Staff Report Z-90-17-4 January 12, 2018

Request From: C-2 TOD-1 (4.97 acres)

Request To: WU Code (Walkable Urban Code)

Location: Southeast corner of 19th Avenue and

Source: Solano TOD District Policy Plan, City of Phoenix Planning and Development Department

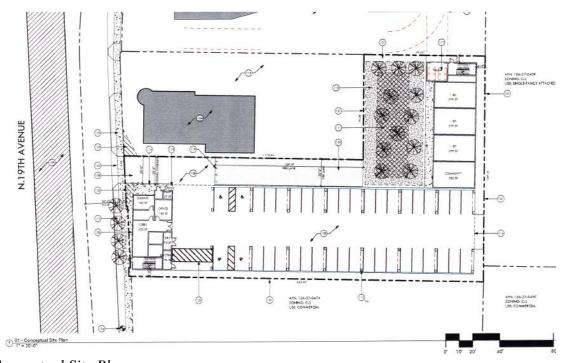
6. The Solano TOD Policy
Plan utilized the Medium
Urban Center place type to
determine the
recommended scale and
character of the area
around the 19th Avenue
and Camelback Road light
rail station, and this scale
and character was
illustrated in both the
conceptual master plan and
the conceptual zoning plan.
The subject site has a

suggested zoning designation of T5:5 with a maximum building height of 56 feet. The request is consistent with the conceptual master plan transect of T5:5.

Source: Architectural Resource Team

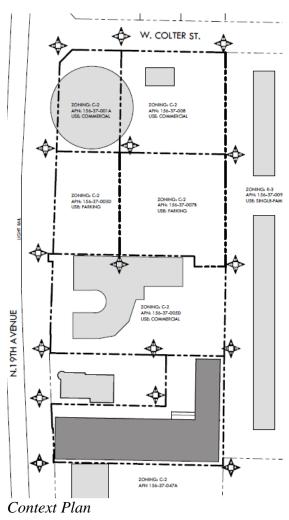
Multiple utility conflicts have been identified running parallel with the proposed sidewalk along the 19th Avenue frontage reducing the ability to plant shade trees in the required minimum five-foot-wide landscape strip between the sidewalk and back of curb. These utility conflicts will require the applicant to consider structural shade elements, trellises, or covered walkways attached to the primary building in order to meet the minimum building and shade requirements of the WU Code Section 1304.F. for this first phase of development. Projections in the right-of-way are permitted with a minimum 16-foot height clearance within six feet of public water/sewer lines, unless shade is retractable or an encroachment permit is secured as administered by the City of Phoenix. Additional Frontage Standards can be found in the WU Code Section 1305. The applicant is encouraged to continue working with staff to update their proposal as it proceeds through the site development review process. This is addressed in Stipulation 2.

- 2. The developer shall work with the Planning and Development Department to determine a frontage type appropriate for the 19th Avenue street frontage which will also provide the shade required by the Walkable Urban Code.
